BUILDING ENVELOPE COMMISSIONING REPORT

Report Date: July 21, 2022
Project Name: Winooski School BECx
Project Number: 21-21-162
Date of Visit: July 19, 2022
Purpose: First Instance Tests - ASTM E 1186 (Fog Testing)

Location:	North Courtyard Elevation in Area D
Location Description:	Wall to Roof Transition with Tectum Ceiling
Test Type:	Pressurized fog at 60+ pascals of pressure (impingement)

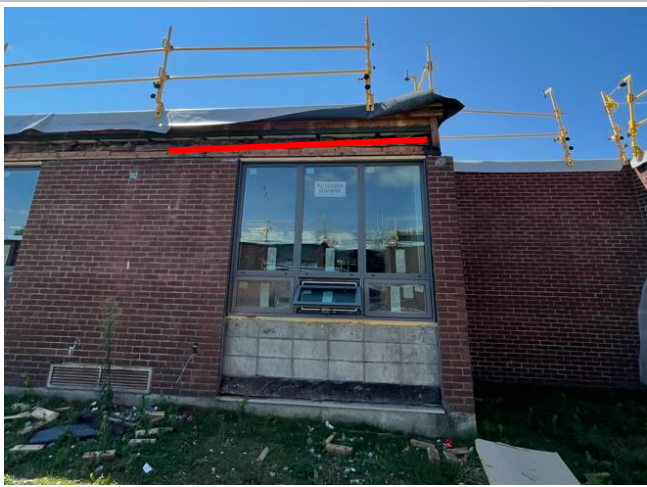
Results: This transition leaked heavily one because it was incomplete, and two because the spray foam only travels up the wall to the bottom of the wall to roof transition beam. With the tectum being porous, air is easily able to leak out here. We recommend to continue work adhering to the 1-A510.2 detail and SKA-28 as these will complete an airtight transition. This will greatly improve the performance of this transition.

The tested transition is outlined above.

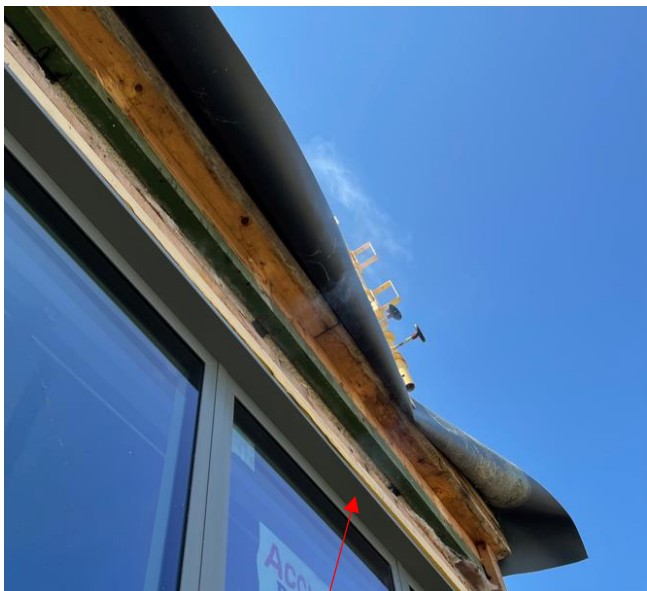
The tested transition is outlined above.

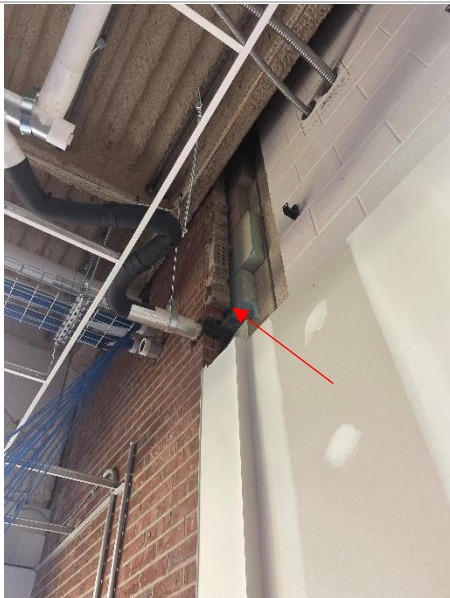
The arrow above points to the air space which leads to outside, We recommend this is filled with can foam along the entire height. Some of the drywall will need to be removed to do this.

The arrows above point to some penetrations through the brick wall which should be sealed from both sides, as they enter the air space.

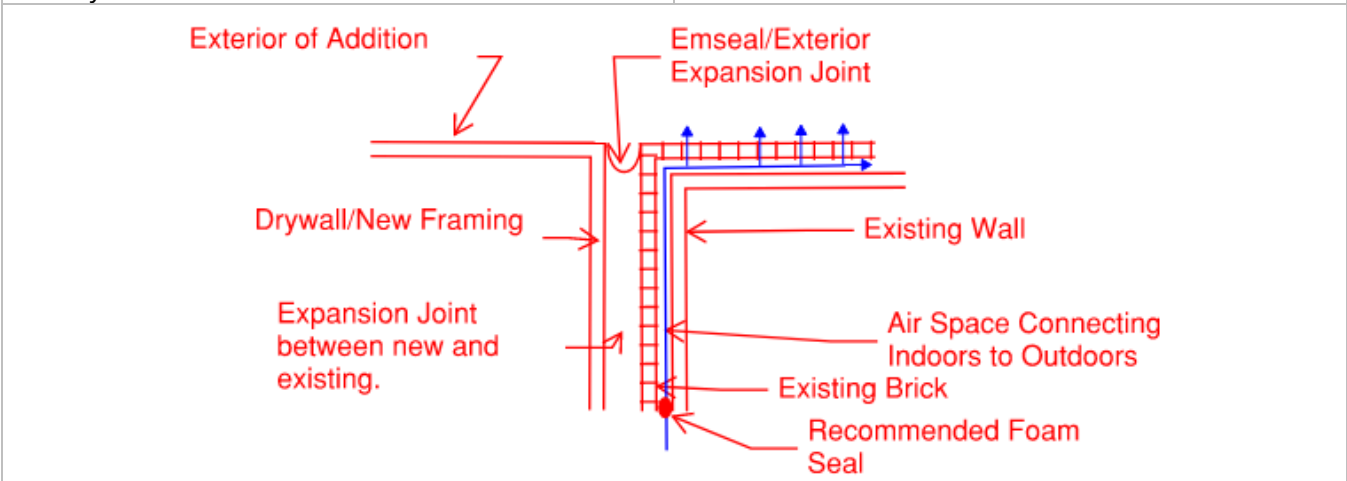
Diagram above is slightly different from what is actually constructed, but it shows how conditioned air (represented by the blue line) can travel into the cavity and out through the existing wall at weep holes, mortar joints, etc.
